**HENDY WIND FARM: Land Off A44 SW Of Llandegley Llandrindod Wells Powys**

**Application for discharge of condition 24 from P/2014/0672 (APP/T6850/A/17/3176128): Water Quality Monitoring Strategy**

## **Hendy Windfarm Development Hydrological Impacts**

Figure 5. The 20m (yellow) and 50m (pink) buffer around waterways (blue) in the area of the wind turbine development site (red outline). Background map OS 1:10,000 open raster.

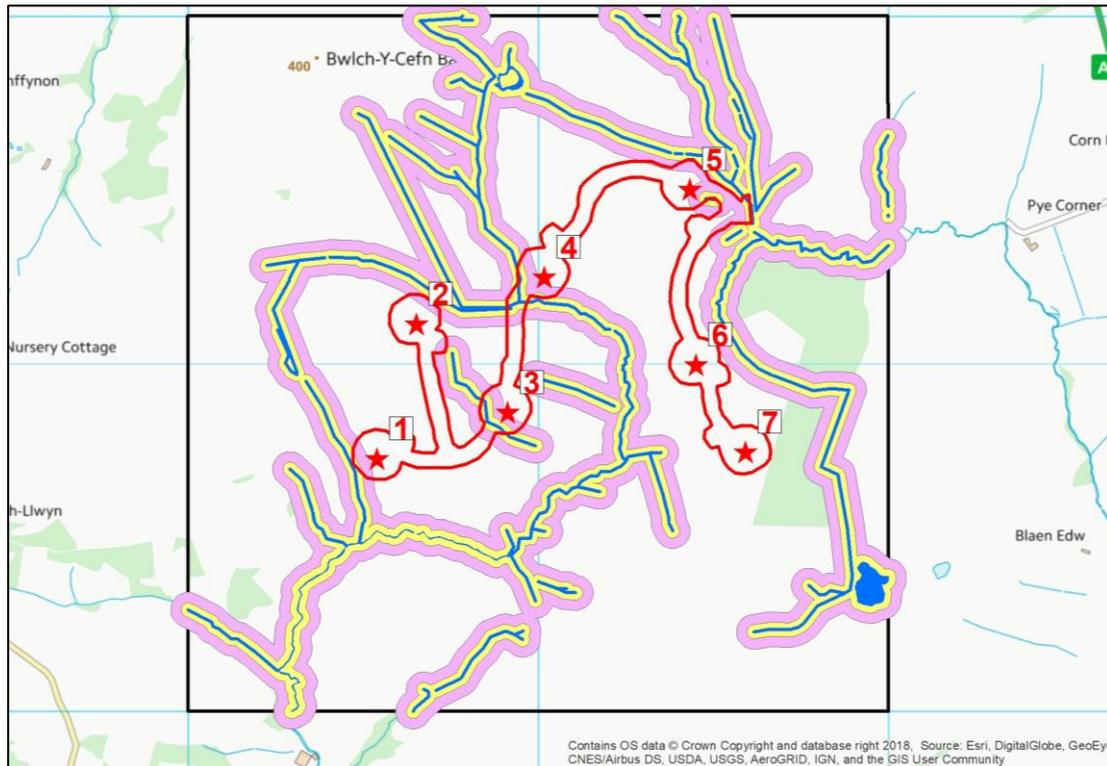
Other methods such as the use of GIS to produce maps and perform spatial analysis should have been demonstrated. For example, a common mitigation method mentioned throughout the SWMP (and ES) is the limiting of any construction work where possible to areas outside buffer from each waterway. The ES used a 20m buffer but the SWMP suggested a 50m buffer. Neither report provided any maps indicating the extent of these buffers in relation to the development area. Such mapping is a relatively straightforward exercise using GIS software. An example of these buffers for the 4km area surrounding the development site is shown in Figure 5.

It is our opinion that both the ES and SWMP do not meet the requirements expected when considering the impact of the proposed development on the hydrology. There is no information on the catchment hydrology and no quantification of the potential impacts and no proper design of mitigation measures including a surface water management plan and monitoring of water sources. This letter has demonstrated our concern through visiting the site and observing the works which are currently being undertaken. It has also provided examples of the type of information which should have been included within the reports for mitigations measures. It is essential therefore that the proper level of information is submitted and approved by the Local Planning Authority prior to the continuation of works.
